SB-10055304-8451

Seat Harness Routing (Non-Swivel)
 VN, VHD, VAH

FSB 375-010, Seat Harness Routing (Non-Swivel)

(March 2014)

W3088546

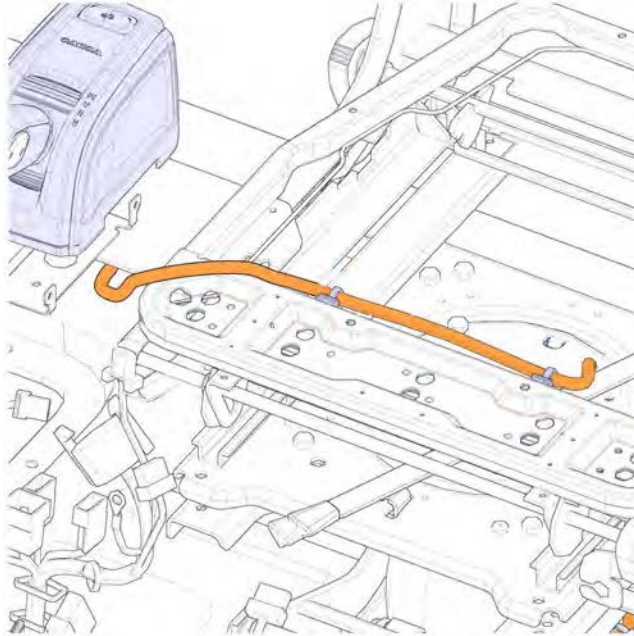
- 4 Look for chafed wires under seat base. Reuse harness if undamaged. If damaged repair as necessary.

W3076417

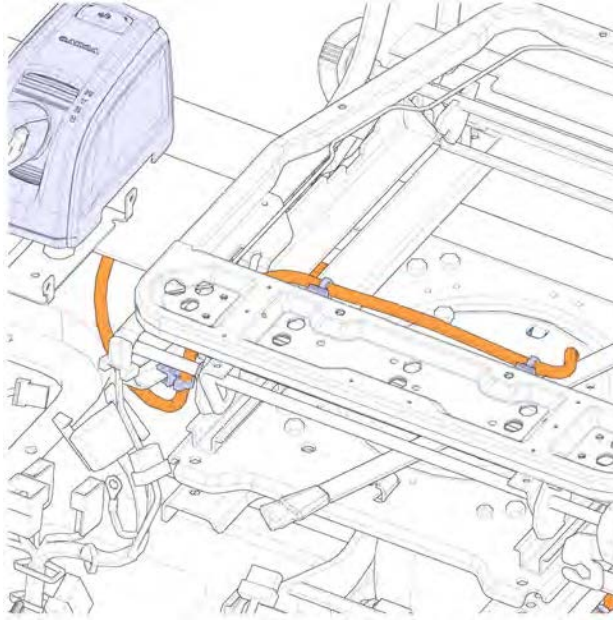
- 5 Flip seat cushion up and loosely install and cable tie the shifter harness along the new path for routing and clipping.

W3076420

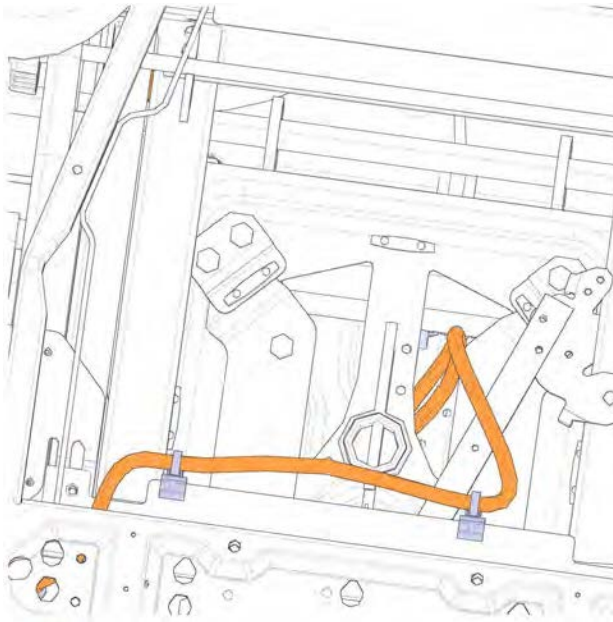
Cable Tie with Horizontal Edge Clip # 21096682, Qty 2

W3076419

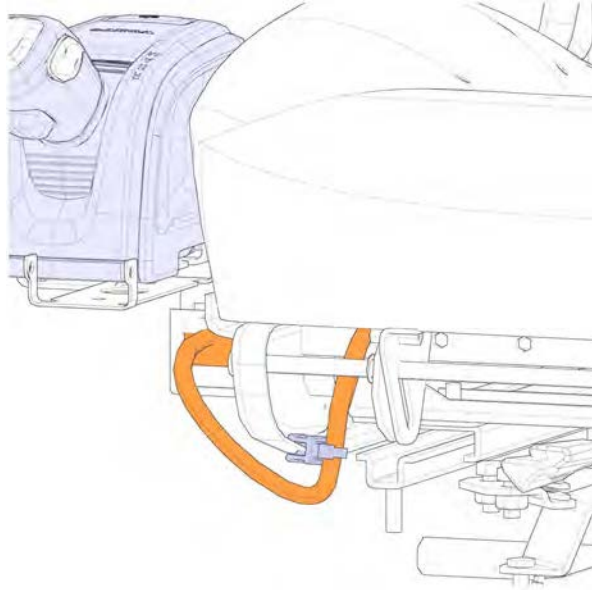
- 6 Secure the shifter harness by cinching all the cable ties until the corrugated loom is lightly snug.

Cable Tie with Vertical Edge Clip # 25375492, Qty 1

Note: Do not over tighten the cable ties, otherwise the wires and loom will become damaged.
